CITY OF SILVERTON

WWTP Primary Sludge Pump Station

## Addendum #1

Project # 23 - 1078

DATE:	JULY 2024
HAZEN NO.:	80011-000
CONTRACT NO.:	PN23-1078
DRAWING NUMBER:	C-2

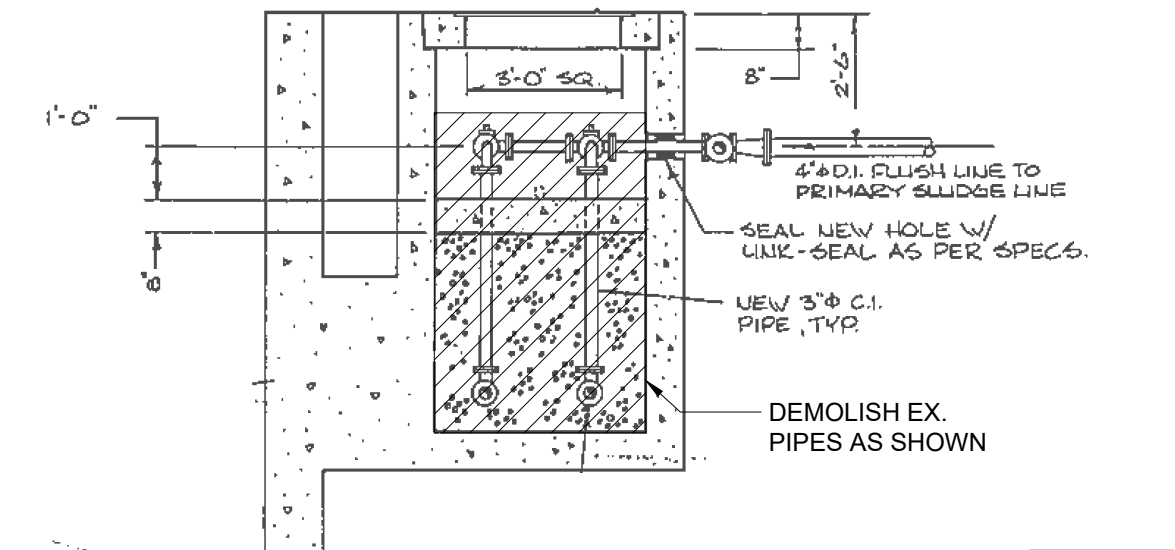
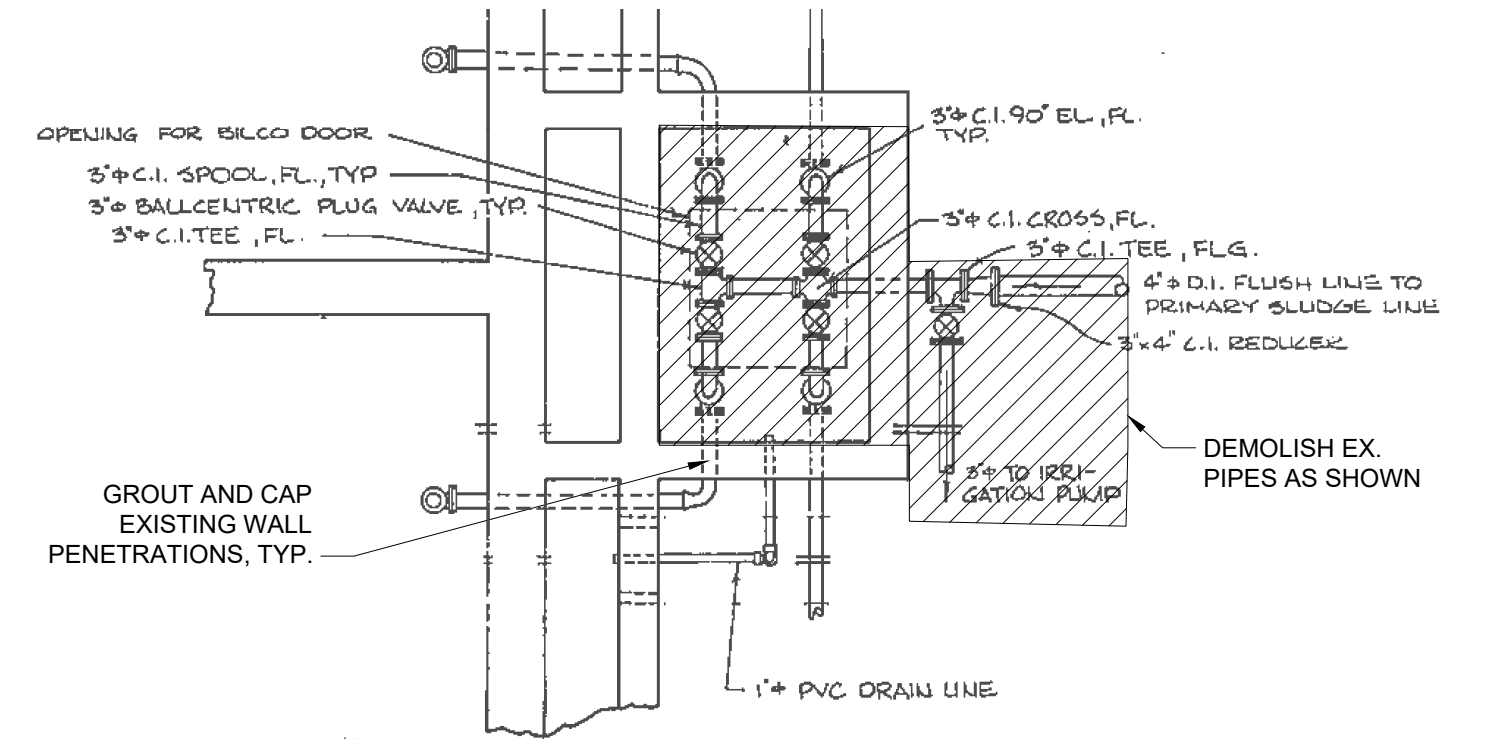
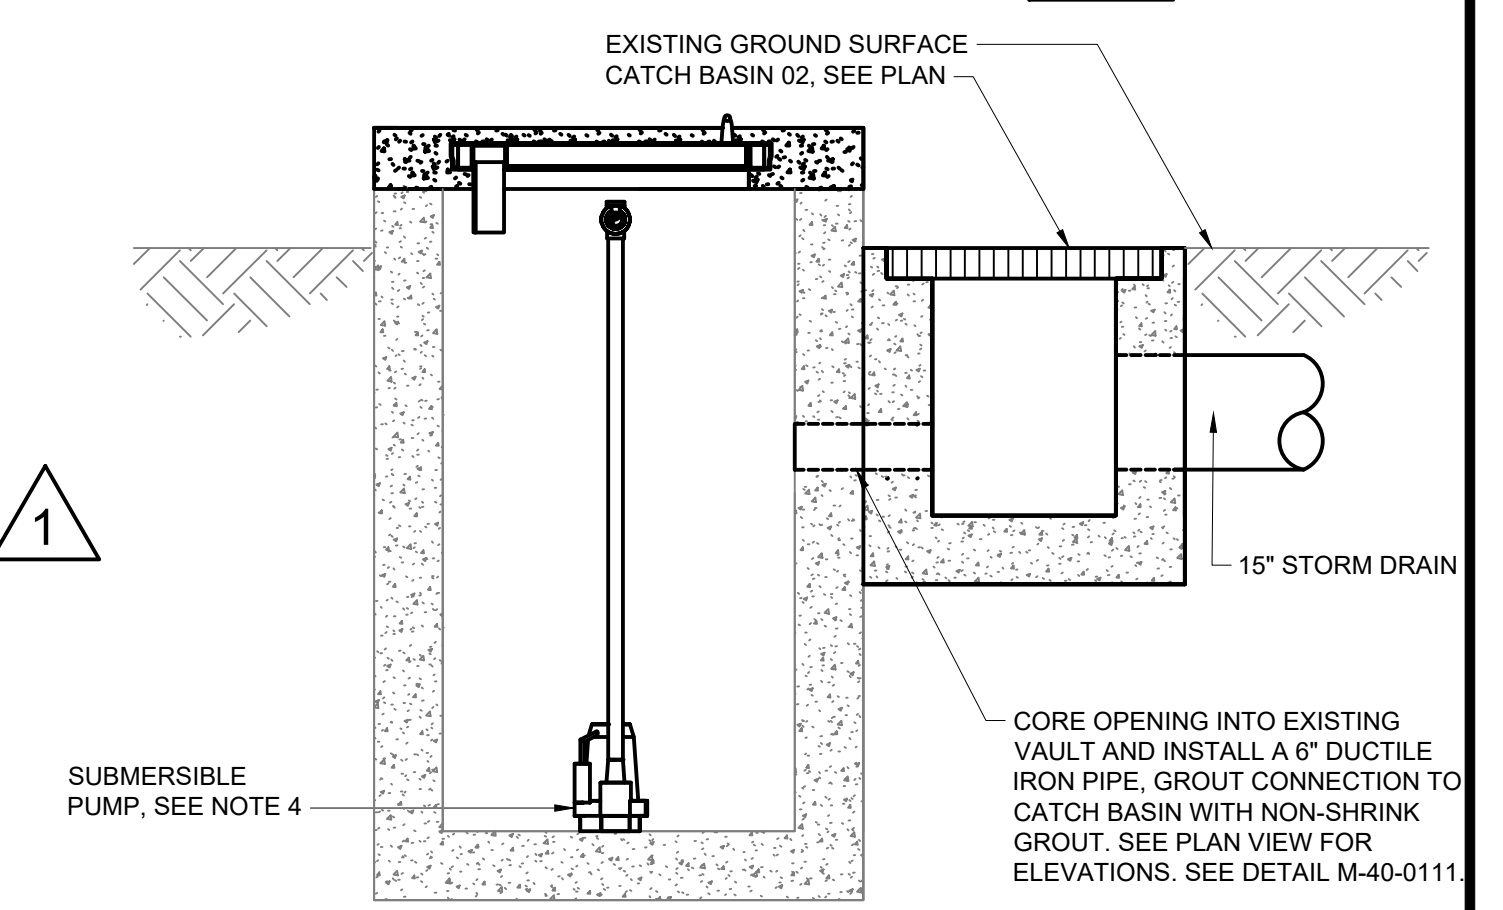
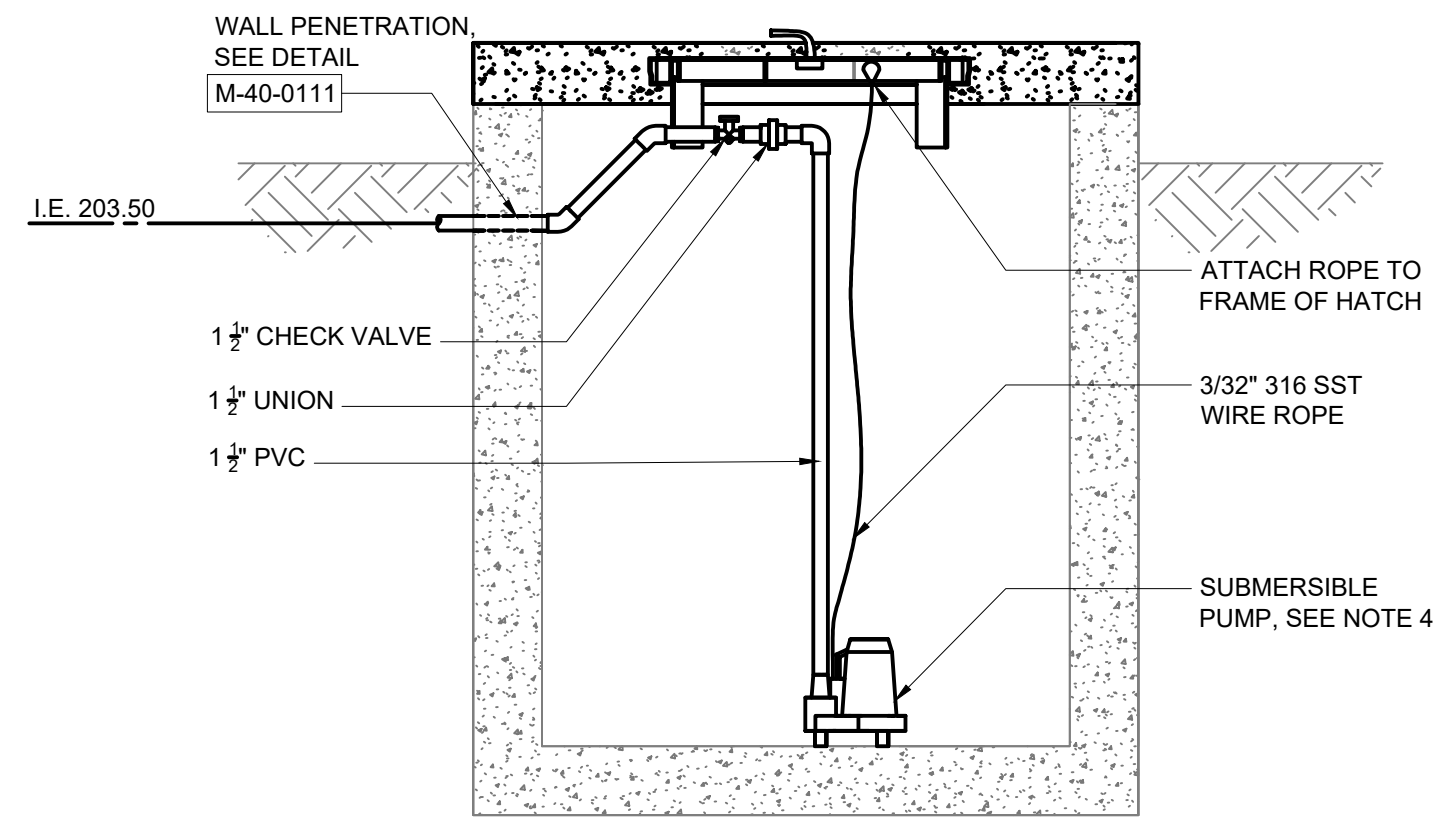
Item #	Specification / Sheet #	Revision or Clarification
1		Bidders are reminded that work must be performed in accordance with State of Oregon requirements for erosion and sediment control. The Contractor should verify total area of disturbance from its laydown and construction activities and confirm that all necessary permits have been secured.
2		All utility construction shall be performed in accordance with the latest edition of the Oregon Standard Specifications and the City of Silverton Public Works Design Standards. In the event of discrepancies, the more stringent requirements as determined by the Public Works Director shall apply.
3	Section 13 34 23- Pre-engineered Utility Building	The City received several questions from bidders seeking additional details about the building design. Bidders should refer to Section 13 34 23, Part 1.01.B which states "Work shall include the supply of a complete engineering design package for the building prepared and sealed by a professional engineering licensed in the State of Oregon." Bidders are also referred to Section 13 34 23, Part 1.01.E which states "Materials for the pre-engineered utility building shall be supplied by the same entity supplying the complete engineering design package." Section 13 34 23, Part 3.01.A indicates that Romtec, Inc. (or an approved equal) are acceptable suppliers for furnishing the engineering and materials covered by the Specification.

- REMOVE EXISTING PIPING FROM EXISTING VAULT AND INSTALL 1/2 HP SUMP PUMP (ZOELLER SUBMERSIBLE SUMP PUMP MODEL NO. 95-005, 68 GPM @ 10 FEET OF HEAD MIN. OR EQUAL). BOTTOM OF VAULT ELEVATION = 198.00'. DISCHARGE FORCEMAIN ELEVATION = 203.50'. INSTALL PER MANUFACTURER'S RECOMMENDATIONS. PROVIDE AN ADDITIONAL PUMP TO OWNER TO BE USED AS A SPARE.

- CORE INTO EXISTING STORM DRAIN INLET. USE NON-SHRINK GROUT TO SEAL CORE AROUND PIPE.
  - CATCH BASINS SHALL BE PER CITY OF SILVERTON STANDARD DETAIL NO. 315.

DATE:	JUNE 2024
HAZEN NO.:	80011-000
CONTRACT NO.:	PN23-1078
DRAWING NUMBER:	M-3

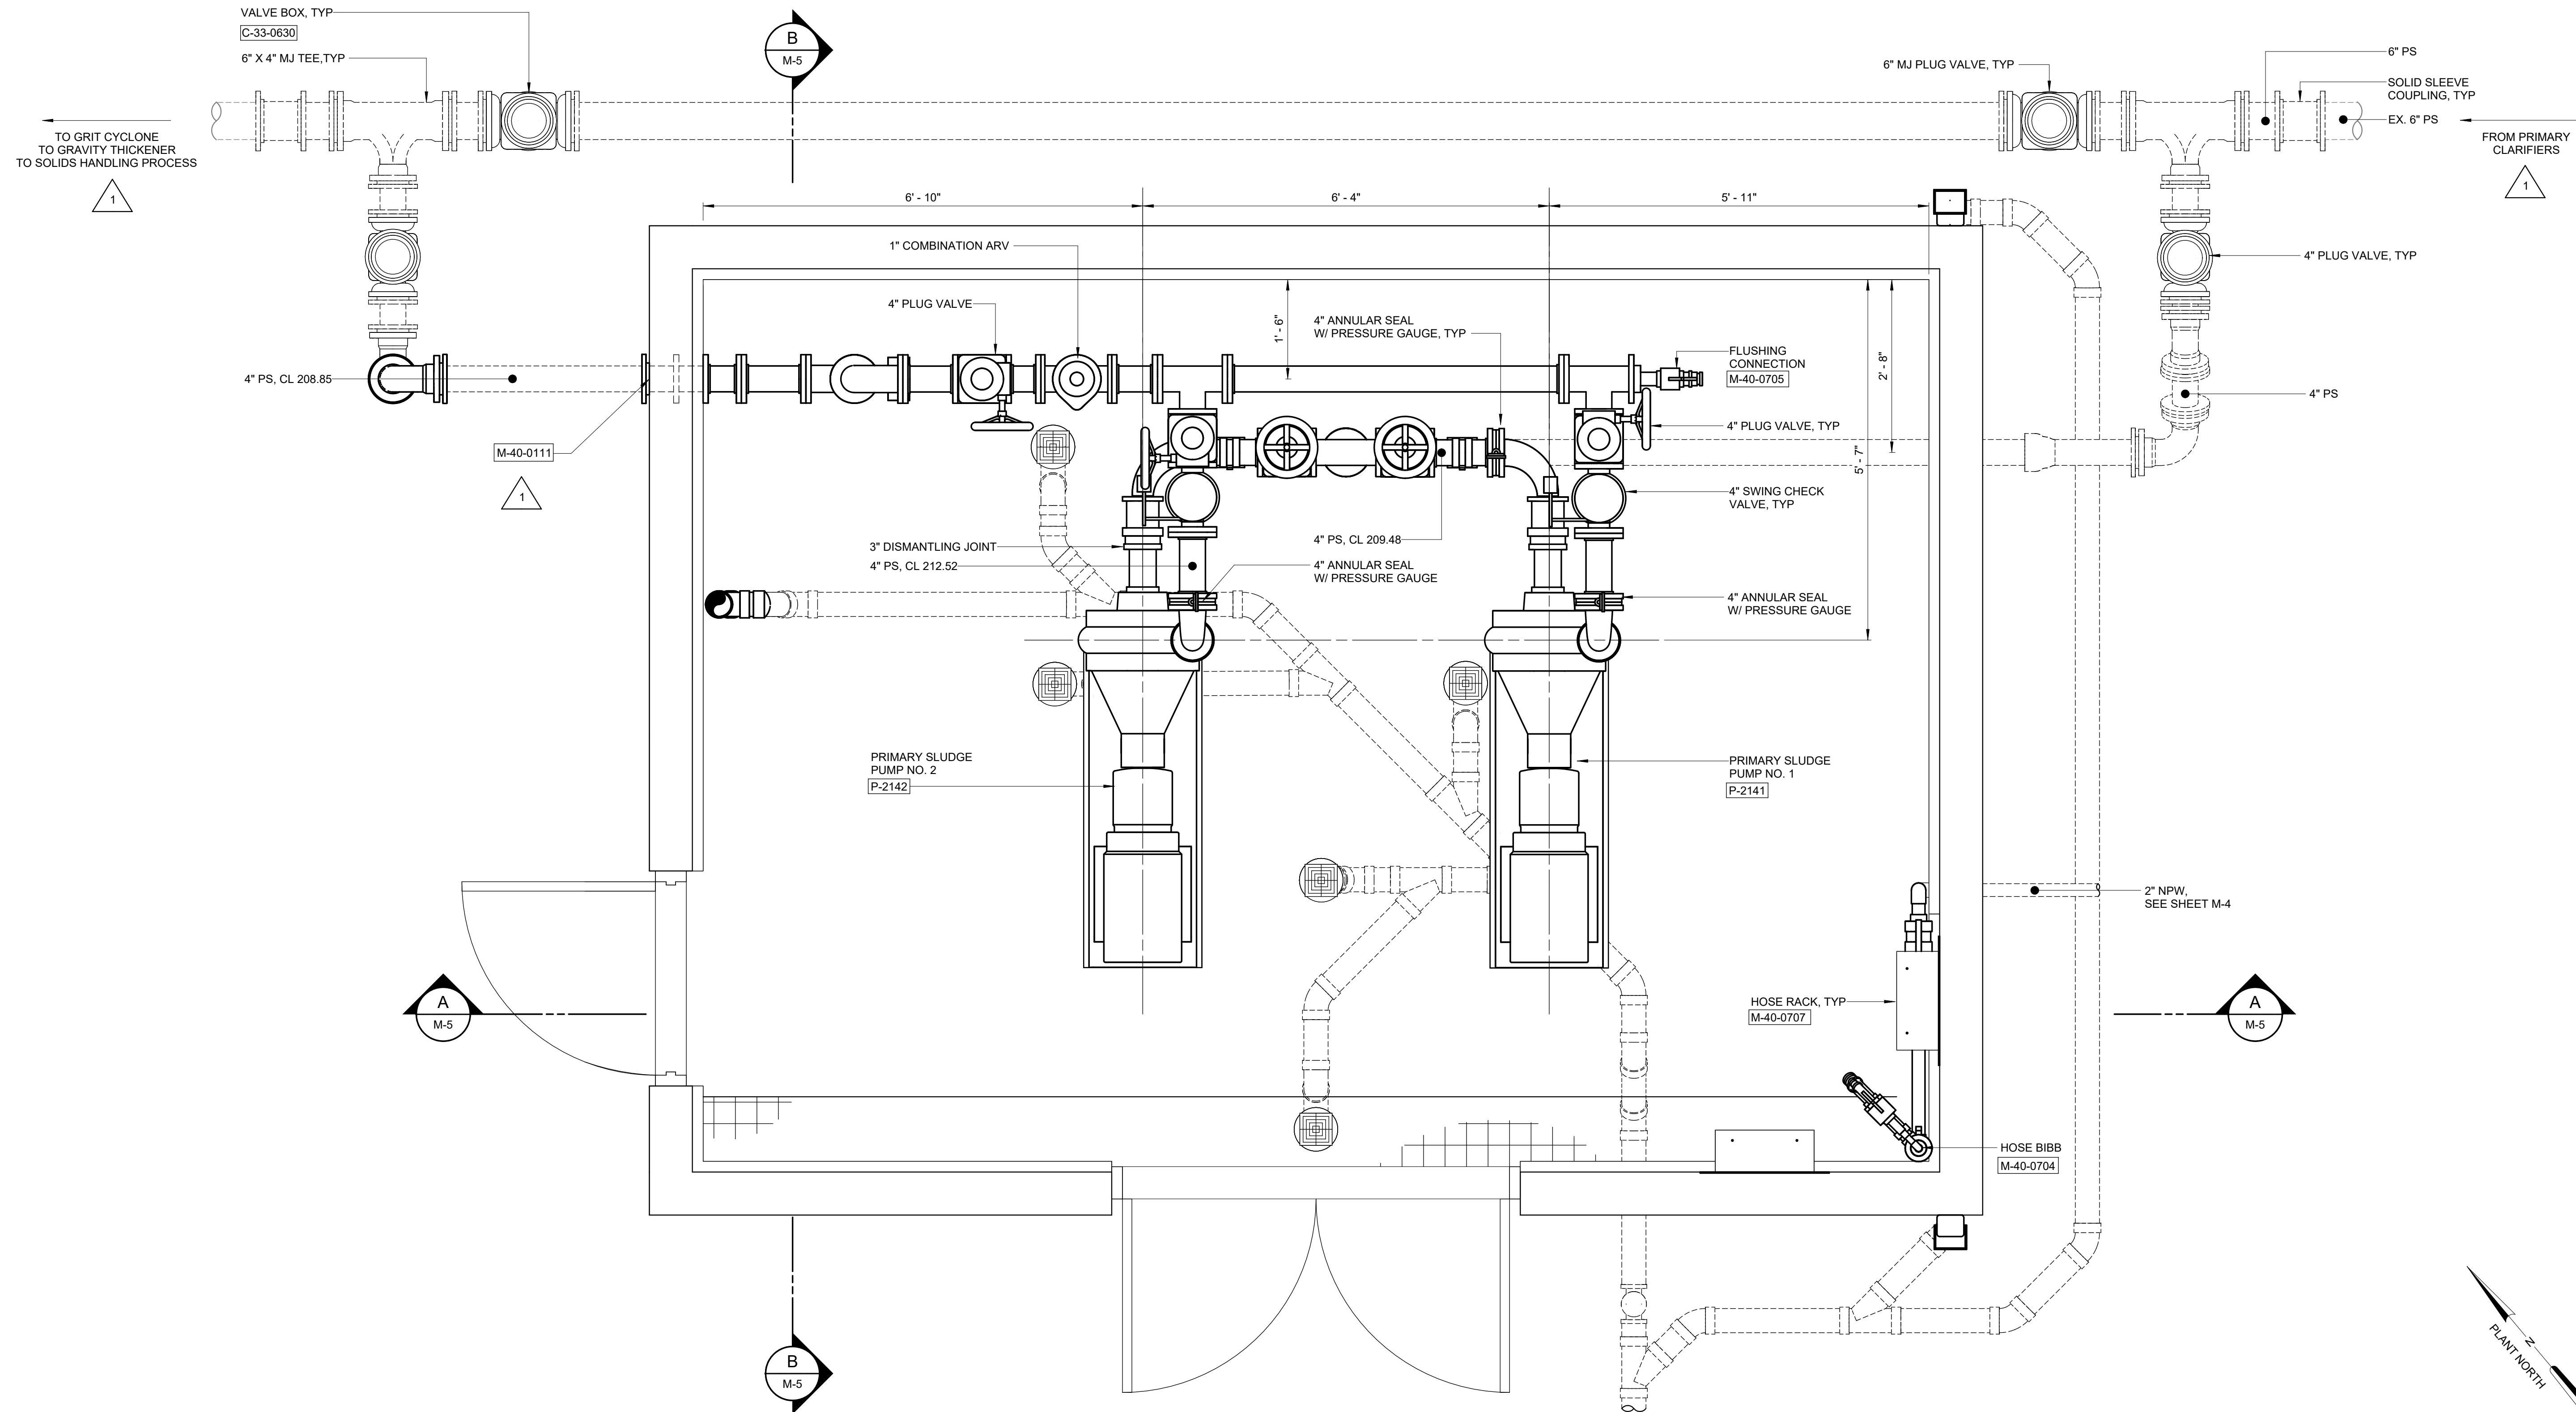
5	Section 43 23 15- Horizontal Recessed Impeller Pumps	<p>Replace the values listed for "Total Head (ft)" under the "Primary Operating Points (reduced speed)" heading in the schedule in Part 1.09.A with the following:</p> <p>Primary Operating Points (reduced speed); Total Head (ft): 9.5, 12, 34</p>
6	Section 43 23 15- Horizontal Recessed Impeller Pumps	<p>Replace the values listed for "Total Head (ft)" under the "Secondary Operating Points (reduced speed)" heading in the schedule in Part 1.09.A with the following:</p> <p>Secondary Operating Points (reduced speed); Total Head (ft): 2, 5, 27</p>
7	Drawing # C-1	Replace Drawing # C-1 with Drawing # C-1 attached.
8	Drawing # C-2	Replace Drawing # C-2 with Drawing # C-2 attached.
9	Drawing # CD-1	Replace Drawing # CD-1 with Drawing # CD-1 attached.
10	Drawing # M-3	Replace Drawing # M-3 with Drawing # M-3 attached.
11	Drawing # M-5	Replace Drawing # M-5 with Drawing # M-5 attached.
